**PLANNING COMMISSION REPORT
REGULAR AGENDA
Public hearing on Variance Requests**

ITEM NO 5: PRELIMINARY PLAT; RIVERSIDE BUSINESS PARK; 30.527 ACRES; 2030 PACKER COURT (MKM)

PP-6-5-10: Consider a Preliminary Plat for Riverside Business Park, a two lot subdivision containing approximately 30.527 acres, located at 2030 Packer Court and variances from Section 20-810(d)(2)(ii) requiring more than one access to the collector/arterial street network and from Section 20-810(d)(4)(i) requiring additional right-of-way for a principal arterial. Submitted by Bartlett and West for Riverside Development, Inc. and Riverside Business Park LLC, property owners of record.

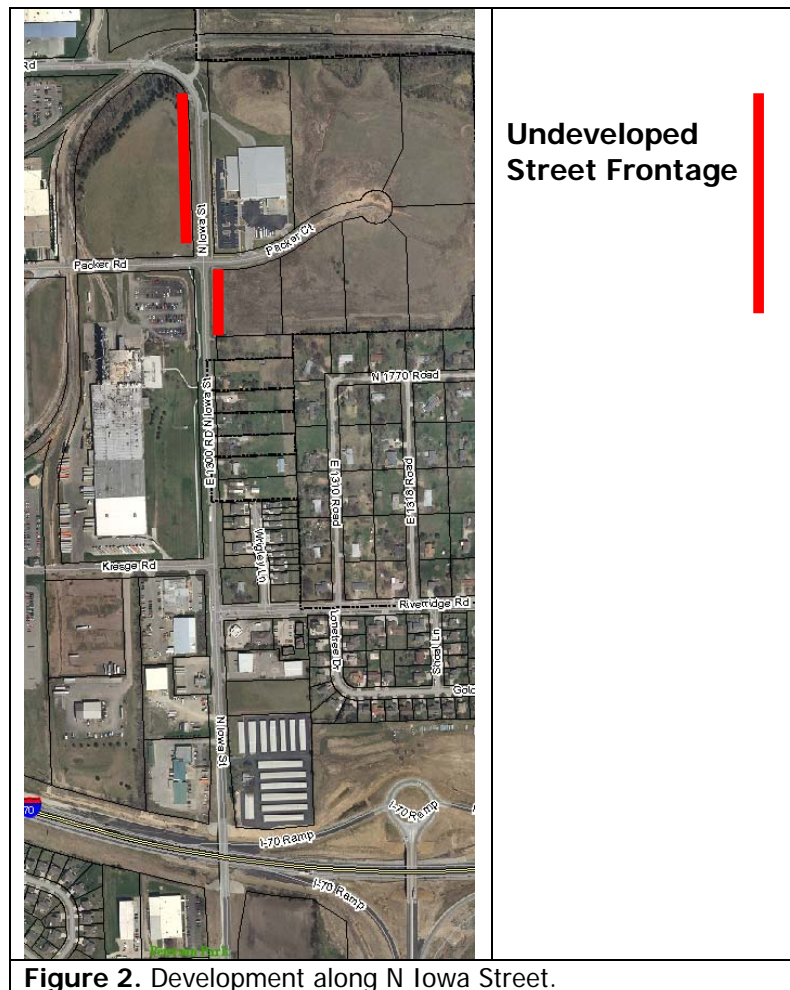
The majority of N Iowa Street has been developed. (Figure 2) It is often problematic to require the additional right-of-way which is required in the Development Code for principal arterials in areas that have been developed or partially developed. As a 20 ft utility easement is provided along the street right-of-way, and it is highly unlikely that N Iowa Street will be widened in the future, the City Engineer indicated he has no objection to the variance.

Staff recommends approval of the variance request from Section 20-810(d)(4)(i) to permit the right-of-way for N Iowa Street to remain at 100 ft in consistency with the remainder of the street.
